Department of Energy
Idaho Operations Office
1955 Fremont Avenue
Idaho Falls, ID 83415

SUBJECT: Response to Request for Additional Information Regarding the Three Mile Island-2 (TMI-2) Independent Spent Fuel Storage Installation (ISFSI) (Docket 72-20) (TAC No. L23812) (EM-FMDP-05-031)

**Response to the May 18, 2005 Nuclear Regulatory Commission
Request for Additional Information Regarding the
DOE Request for License Amendment for the Three Mile Island Unit 2
Independent Spent Fuel Storage Installation
TAC No. L23812, Docket 72-20**

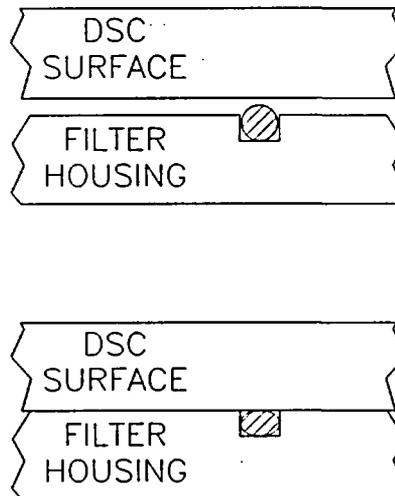
Request 4-2: Justify that the new polymeric o-rings can withstand the same torque as the metal seals without damaging the polymeric o-ring. The license amendment request states that the same amount of torque (82 ± 5 ft-lb) used for the old metal seals will be applied to the new replacement of elastomeric o-rings.

Response 4-2: The sealing capability provided by the elastomeric o-ring results from compressing the o-ring seated in the filter housing o-ring groove against the mating DSC surface. Compression, as defined by the manufacturer, is the diameter reduction from the no load condition to the compressed condition. The amount of compression that would be applied to the elastomeric seals under the above joint configuration is within the range recommended by the o-ring manufacturer.

The bolt torque specified in the TMI-2 ISFSI SAR generates a metal-to-metal compressive preload between the filter housing and the DSC surface, creating a closed static (non-moving/non-flexible) joint. In other words, the metal face of the DSC surface is in contact with and compressed against the metal face of the filter housing under all service conditions. The following sketch, not drawn to scale, is provided to show the proposed placement and seating of the elastomeric o-rings in the filter housing groove and the mating DSC surface.

The torque applied to each bolt (82 ± 5 ft-lbs each) equates to a minimum bolt preload of 4,863 lbs. each for a total compressive load (with eight bolts per filter housing) of 38,904 lbs. Some of the load is needed to compress the seals located in grooves in the filter housing. Once a metal-to-metal joint is achieved, the seals (either metal or elastomeric) are appropriately compressed and no further seal compression occurs. The remaining compressive load is absorbed by the metal-to-metal interface between the filter housing and the DSC surface and is designed to ensure metal-to-metal contact during the normal and accident conditions addressed in the SAR.

The bolt torque specified in the SAR provides a compressive load of 21,865 lbs to seat the metal seals (300 lbs/in for two seals of 10.8" and 12.4" diameter) before metal-to-metal contact is achieved between the filter housing surface and the DSC surface. The remaining compressive load of $(38,904 - 21,865 =)$ 17,039 lbs preloads the interface of the filter housing to the mating DSC surface. When elastomeric seals are used, the compressive load applied to the seals diminishes significantly due to the more elastic properties of the elastomeric seal material. The force required to seat the elastomeric o-rings is calculated from the manufacturer's design charts at (35 lbs/in for two seals of 10.8" and 12.4" diameter \Rightarrow) 2,551 lbs. This application results in $(38,904 - 2,551 =)$ 36,353 lbs as the remaining compressive preload between the filter housing and the mating DSC surface. Therefore, use of the elastomeric o-ring increases the metal-to-metal joint preload by $(36,353 - 17,039 =)$ 19,314 lbs over the use of the metallic seals. Though this excess joint preload is unnecessary from a joint design standpoint, it is preferred to keep all the bolt torques the same for consistency of operations rather than to reduce the bolt tightening torques for those joints which would utilize the elastomeric seals.
